IDAHO TRANSPORTATION DEPARTMENT

SUBJECT: 2023 5010-1 Airport Inspection conducted May 31, 2023.
(04235.9*A Lucille Big Bar USFS)

Runway 17-35:

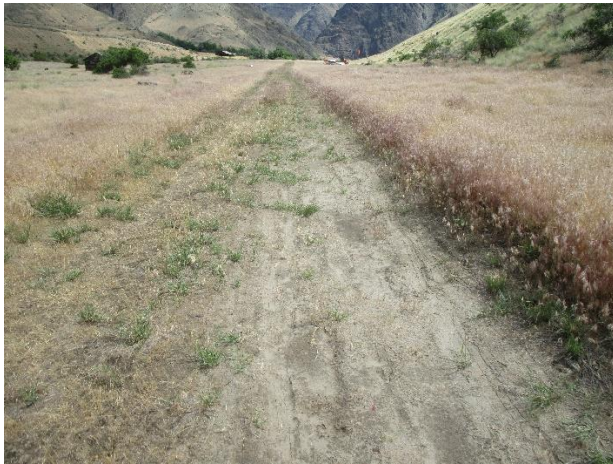
Continues to be in fair condition. The rwy. is not the smoothest surface and presented a few undulations during landing; take-off was equally rough. Rwy. end 35 - first 150ft of the rwy. is very rough due to sloping & uneven terrain; it has serious undulations. The strip could use a mowing as vegetation/grass was growing almost everywhere and is 18 to 20" tall, especially at both ends of the rwy. Outside the 15'-18' center portion used for landing & take-off, there are a bunch of larger size rocks hidden in the taller grass on the sides of the rwy. – some are painted white, and some are not. Not sure how many rocks are within the perimeter of the rwy. & inside the boundary markers (BMs), but remember that the airport owner/sponsor is responsible for maintaining the surface within those BMs and liable for all that could happen inside that area. The approaches at both ends continue to remain the same and with the same controlling obstructions as listed in the Airport Master Record.

1. Mow the rwy. area to match your declared dimensions on the Airport Master Record,
2. Redo the BMs and be consistent with VFR Airports Design Guidelines (if interested, I have info that I could share with you on this).

Boundary Markers (BMs):

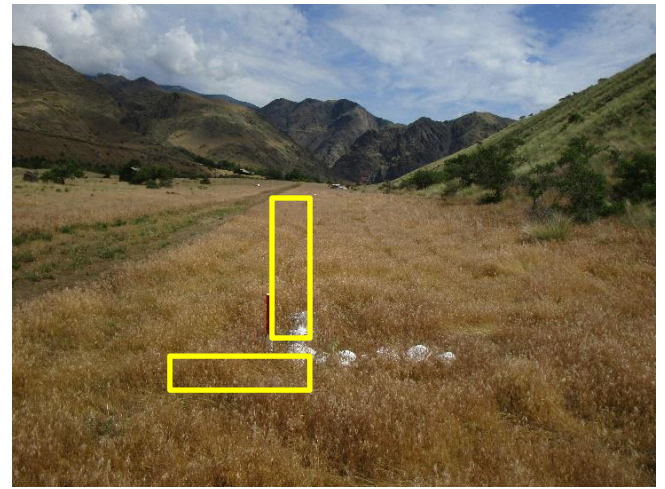
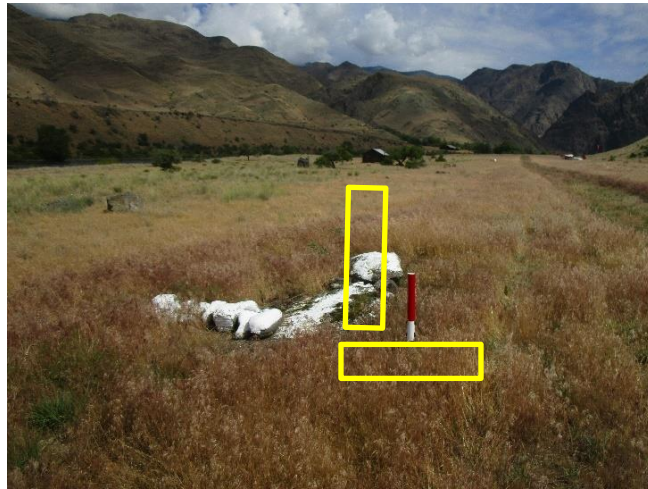
The existing non-standard rock BMs located at rwy. end 17 are good, in place and have good paint coverage. Grass growth is encroaching, and the rocks are being taken over (through & around the rocks) by tall grasses (15-18" tall) and other vegetation. At rwy. end 35 the rock BMs are installed incorrectly "└┐" vs the normal inward L shape "└┐".

1. Grass should be pulled/mowed/cleaned out/sprayed to sterilize the area of all the BMs and not have to contend with the grass growth on a yearly basis,
2. Redo the BMs at rwy. end 35 to resemble a normal inward “|_ _|” shape vs the now _| _|” (follow the yellow markings in the pics above for proper positioning) and relocate the red reflectors to the outside corner of the Ls.
